REQUEST FOR INFORMATION	DATE: August 30, 2016	NO.: RFI-260
--------------------------------	------------------------------	---------------------

Project Name: 15051-Webster University Interdisciplinary Science Building	Project No.: 15051
---	--------------------

Subject: Maximum height of water flue above parapet

DOMESTIC WATER HEATER INTAKE/EXHAUST (NOT TO SCALE)

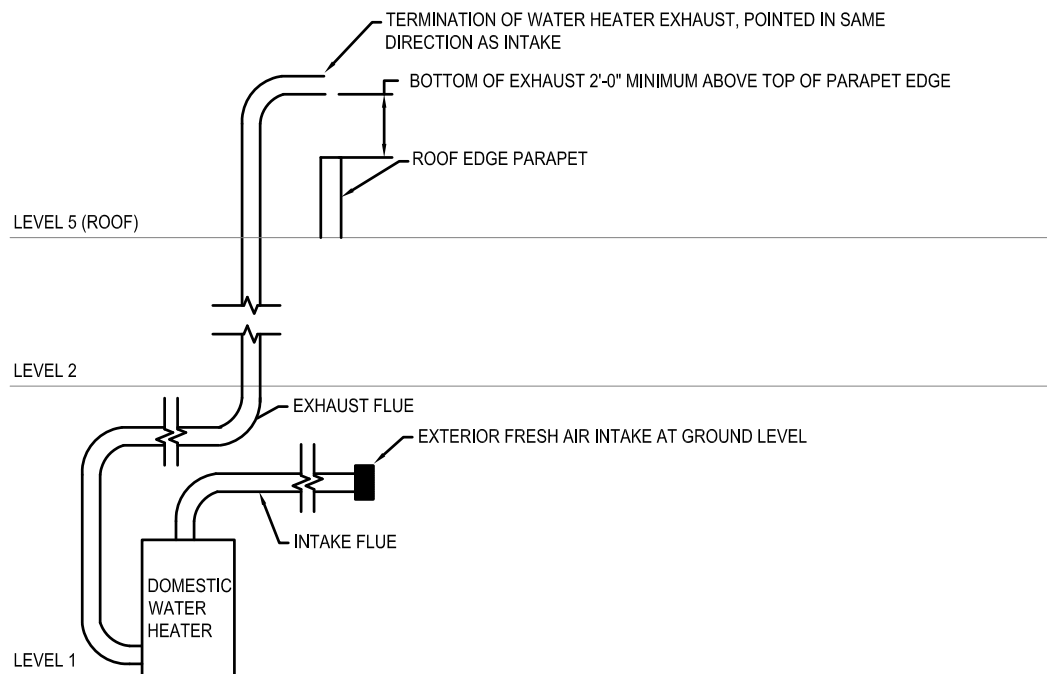
To coordinate further with water heater suppliers, please provide the maximum acceptable height above the top of parapet as well as maximum closest point to the edge of the building. See attached sketch for reference only.

Per the design the flue vent shall discharge vertically and shall be installed per local codes.
This is a similar question as 169 and 232.
